**ADDENDUM NO. 6**

Date: September 28, 2018  
Project: **Secondary Treatment Plant Upgrade & Recycled Water Expansion**  
Job No.: 12600-07/16650-02

Las Gallinas Valley Sanitary District:

ELECTRICAL – POWER DISTRIBUTION  
DUCTBANK CROSS SECTIONS 1

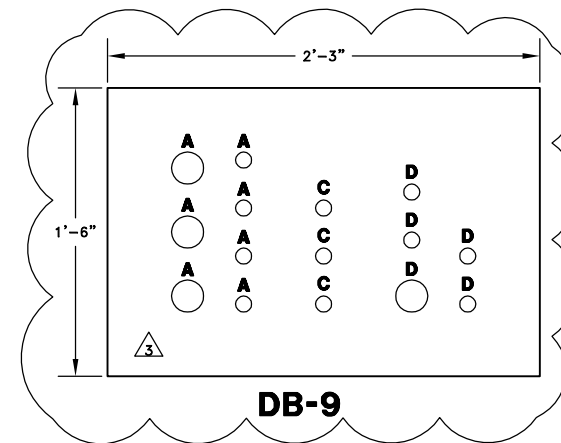
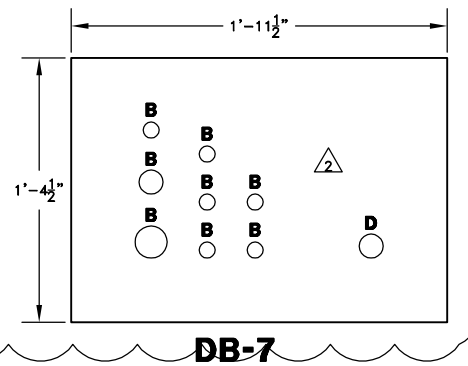
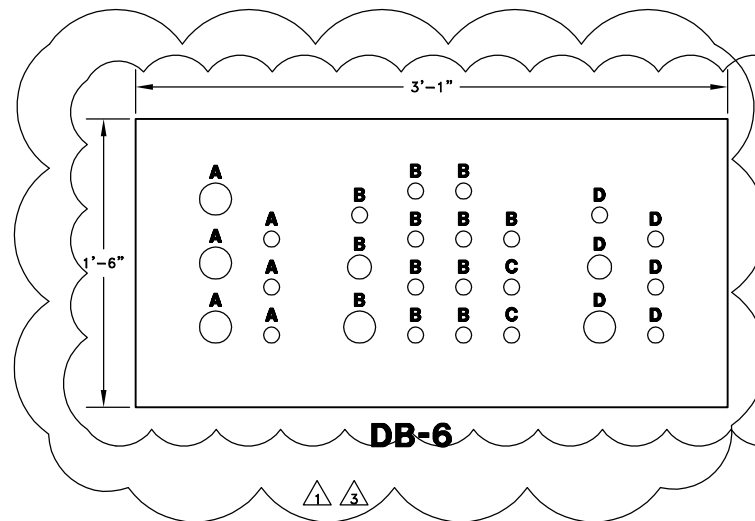
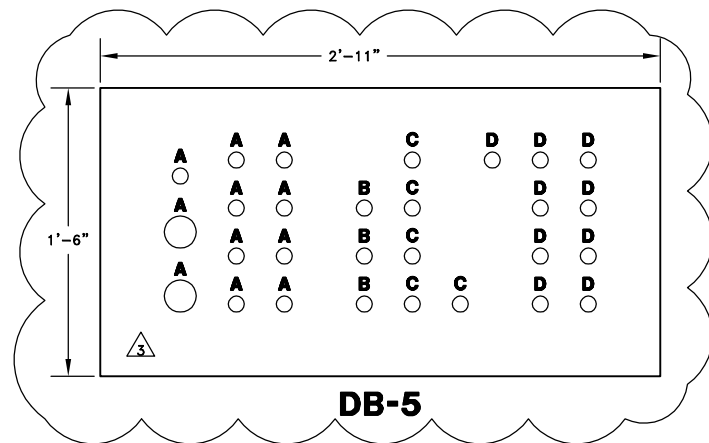
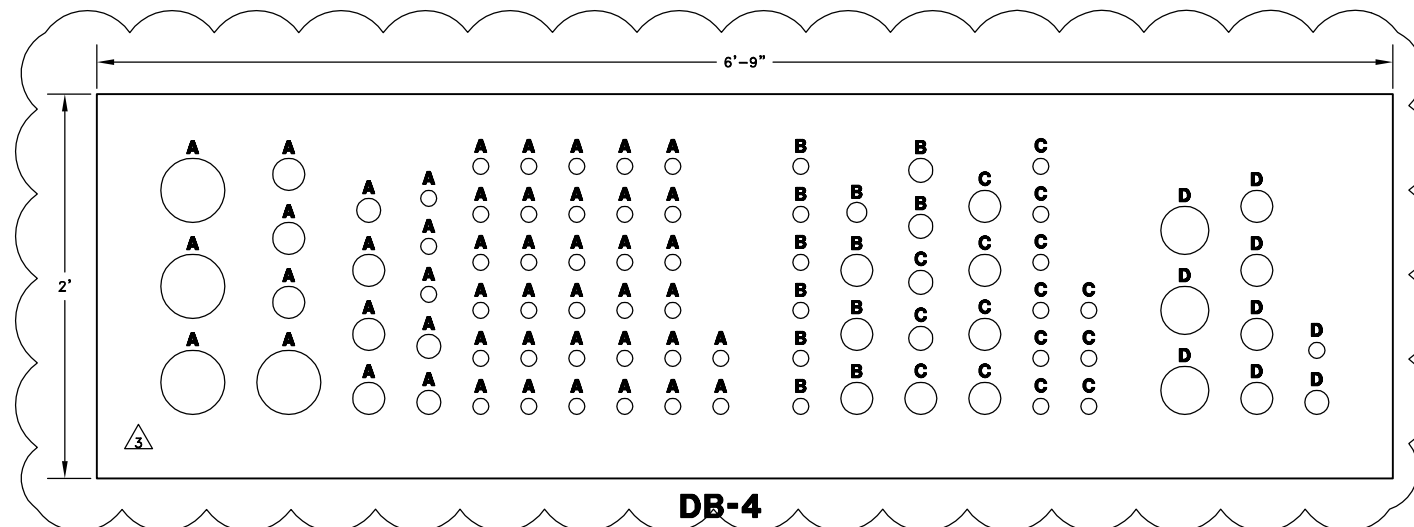
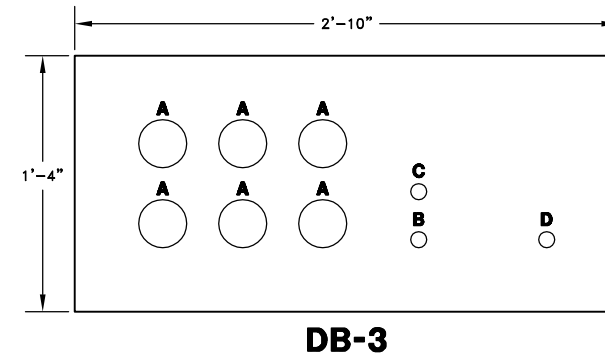
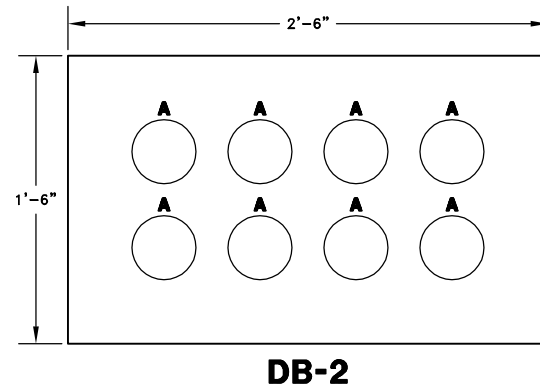
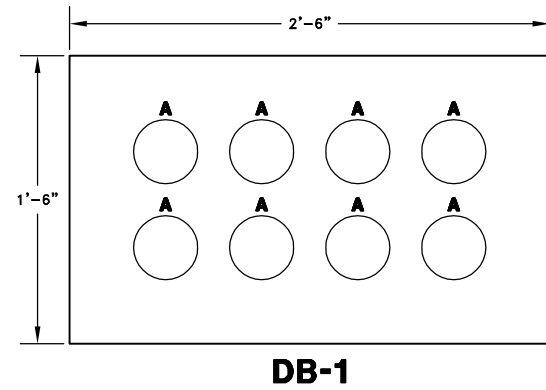
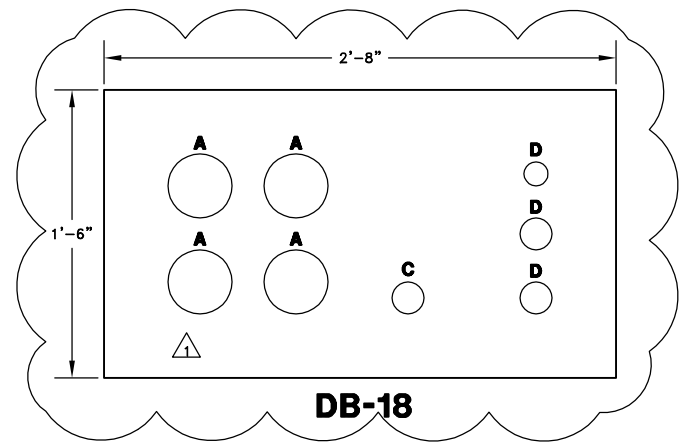
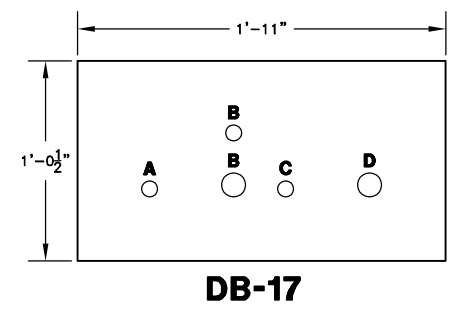
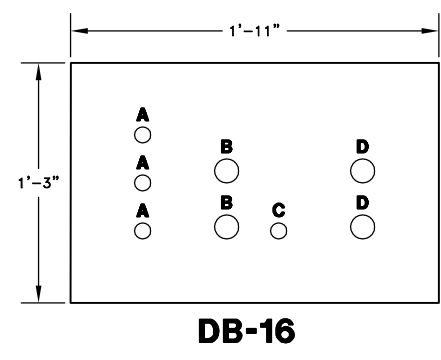
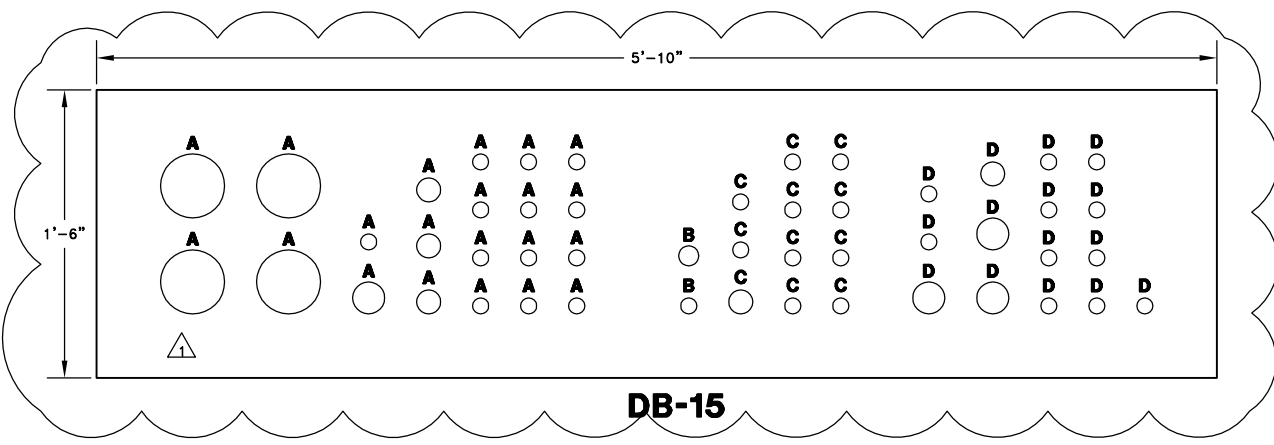
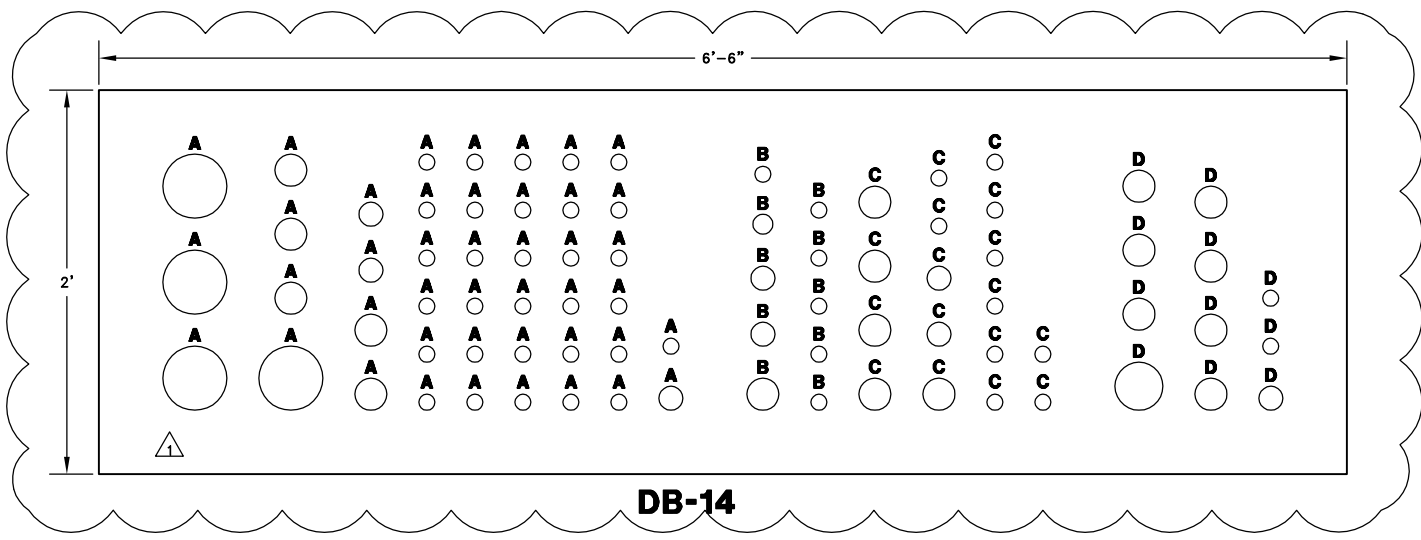
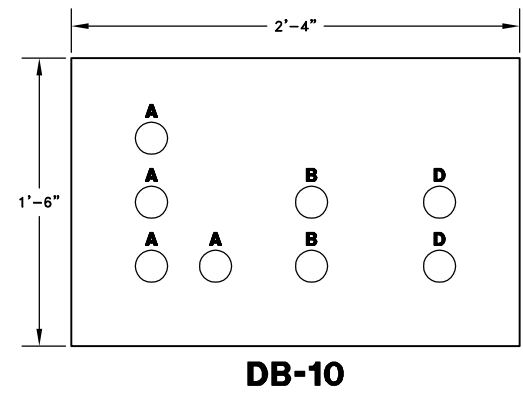
1. **Sheets E-44 and E-45:** Several conduits were changed to match sizes as shown in the conduit schedules – the changes are as follows:
  - a. DB-4
    - i. P23-1300A, P23-1400A, P23-1500A changed to 1.5"
    - ii. SP31-2000A changed to 2"
    - iii. SP31-1110A changed to 3"
  - b. DB-5

- i. P108A changed to 1”
    - ii. P110 changed to 1.5”
    - iii. Change the second P44-1621 to P44-1631
  - c. DB-6
    - i. C52-1013A changed to 1”
  - d. DB-7

- i. P067 changed to 1”
    - ii. P43-1000B changed to 1.5”
  - e. DB-9
    - i. C52-1013B changed to 1”
  - f. DB-14
    - i. P23-1300B, P23-1400B, P23-1500B changed to 1.5”

- ii. P23-1000B changed to 1.25”
    - iii. SP31-2000B changed to 2”
  - g. DB-15
    - i. P23-1300C, P23-1400C, P23-1500C changed to 1.5”
    - ii. P23-1000B changed to 1.25”

- iii. C36-1400C changed to 1”
    - iv. S31-2001A was deleted
  - h. DB-18
    - i. C51-2100A changed to 2”
  - i. DB-19
    - i. P121 removed
  - j. DB-25

- i. P62-2100 changed to 2”
  - k. DB-36
    - i. S36-1410 changed to 1”
- 2. **Sheets E46 thru E-48:** Ductbank cross sections are re-issued to reflect changes in duct bank schedule. **Revised versions of these sheets are provided as an attachment to this addendum.**
